7009 GREENWOOD AVE N

Design Review Recommendation Meeting
May 1, 2017
SDCI Project # 3023260

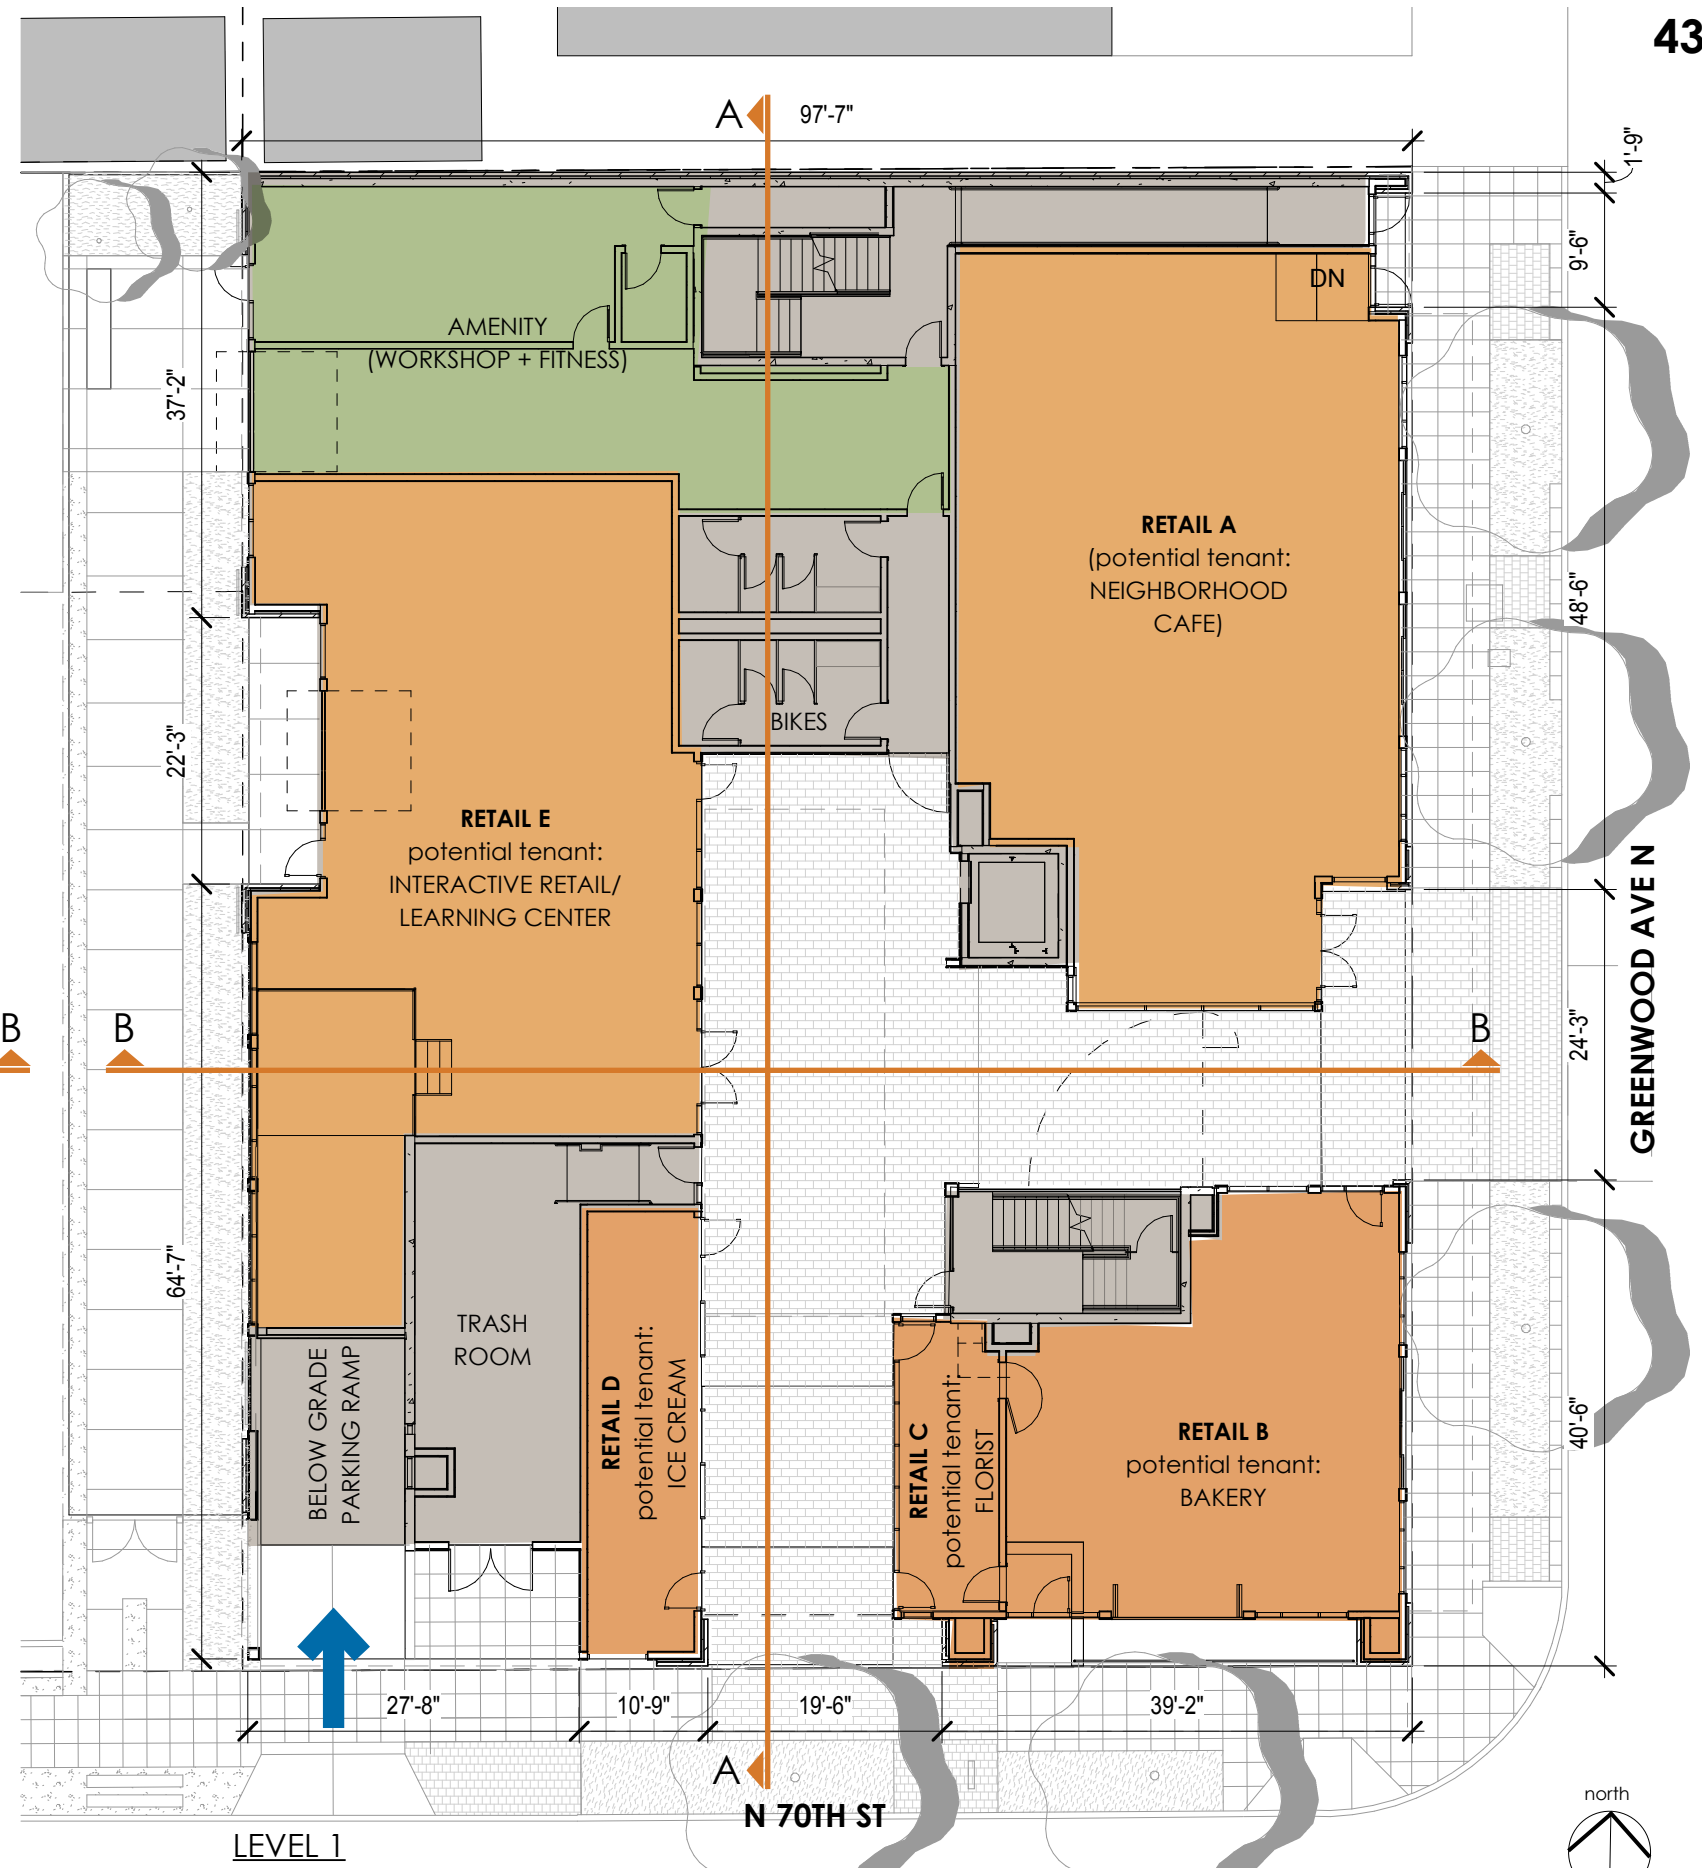
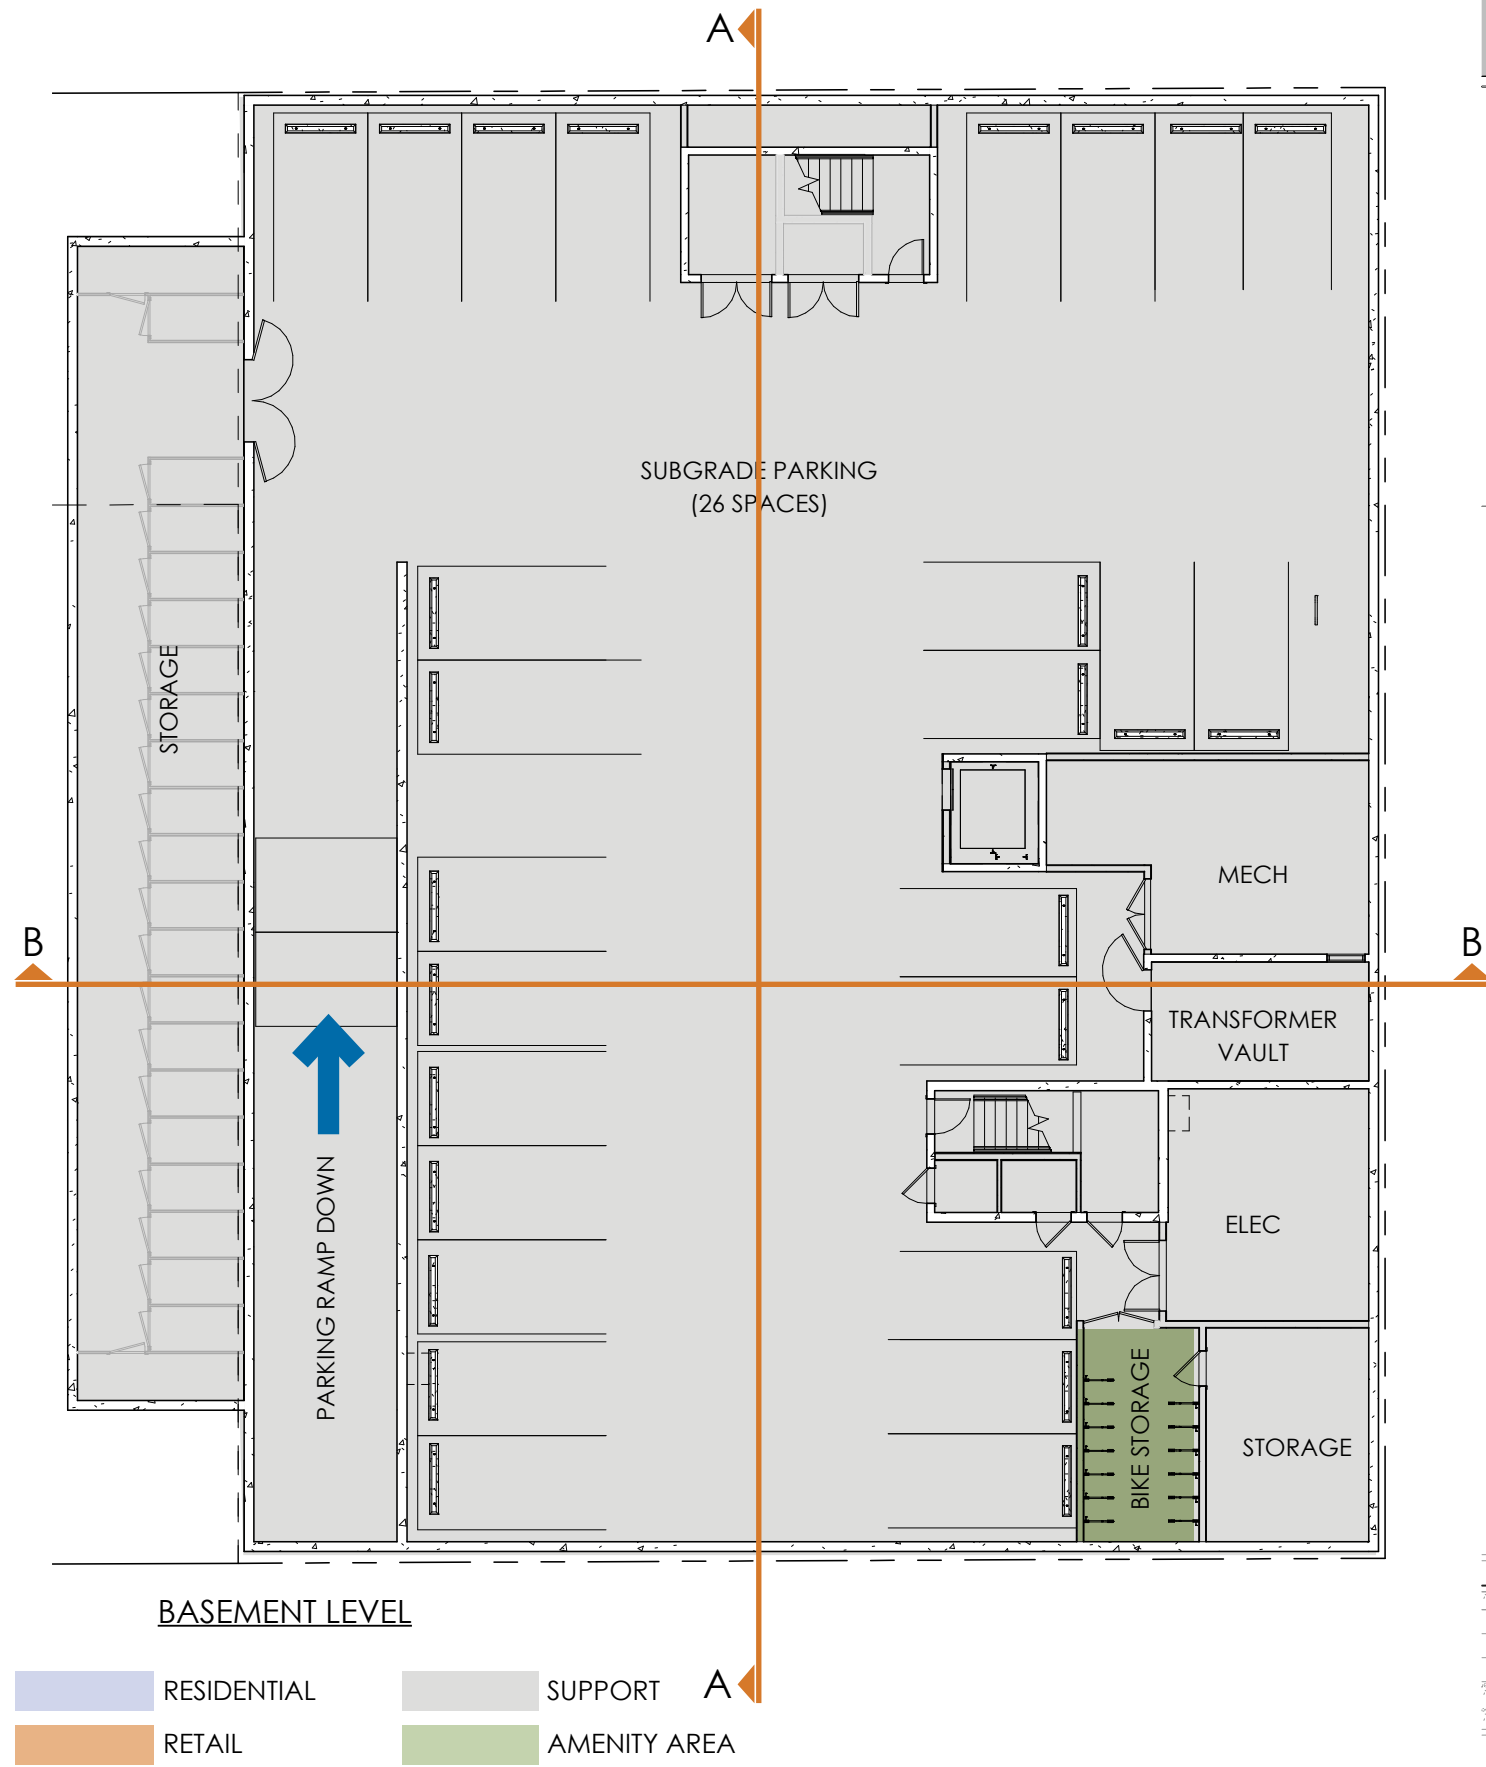
direction: The Board noted that the “proposed building is located within a neighborhood with strong residential character” and requested more information showing “how the design parti and material application will reduce the scale of the building” and “utilize durable, high quality materials”

response: Siding material and window pattern is varied at areas of modulation, strengthening the visual break in the massing to reduce scale. The project’s primary street-facing facades will feature brick, a prominent material in the neighborhood with a durable, high-quality, historic/timeless, and human scale character. Supporting materials will include textured board-formed concrete along the building base and cement board panelized siding at areas of inset modulation and at upper floor setbacks.
